Access Compliance Report Public Rights-of-Way (Curb Ramps)

Intersection ID: 23784Main Street:E_WESTINGHOUSE_BVCross Street:NATIONS_FORD_RDLocation:NEADA ID: 28235D25215FRamp Type:PerpInitial Pass/Fail:FailOverall Compliance:NoSeverity Score:22.5

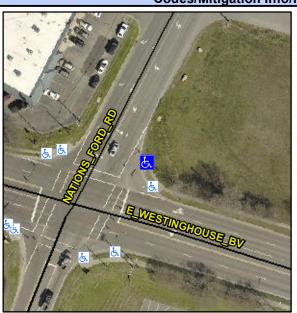
Not Found, R304.5.1, R304.2.2, R304.5.3

Field Measurements/Component Compliance					
Comp	liance Description	Data	Comp	liance Description	Data
N/A	Ramp Length (in)	89.0	No	Ramp Slope (%)	11.9
No	Ramp Width (in)	44.0	No	Ramp XSlope (%)	3.5
N/A	Flare Type LT	N/A	N/A	Flare Type RT	N/A
N/A	Flare Slope LT (%)	N/A	N/A	Flare Slope RT (%)	N/A
N/A	Flare Traversable LT?	N/A	N/A	Flare Traversable RT?	N/A
N/A	Landing Length (in)	N/A	N/A	DWS Provided?	N/A
N/A	Landing Width (in)	N/A	N/A	DWS Contrast?	N/A
N/A	Landing Slope (%)	N/A	N/A	DWS Length (in)	N/A
N/A	Landing X Slope (%)	N/A	N/A	DWS Full Width?	N/A
N/A	Landing Curb? (Y/N)	N/A	N/A	DWS Offset (in)	N/A
N/A	Shared Landing?	N/A			
N/A	Gutter Ponding?	N/A	N/A	Gutter Slope (%)	N/A
N/A	Gutter Lip Ht (in)	N/A	N/A	Gutter X Slope (%)	N/A
N/A	Painted X Walk1?	Yes	N/A	Painted X Walk2?	N/A
	X Walk 1 Direction	To W		X Walk 2 Direction	N/A
N/A	X Walk 1 Width (in)	102.0	N/A	X Walk 2 Width (in)	N/A
	X Walk 1 Slope (%)	0.3		X Walk 2 Slope (%)	N/A

Remove & Replace Entire Ramp.
Restripe Crosswalk.
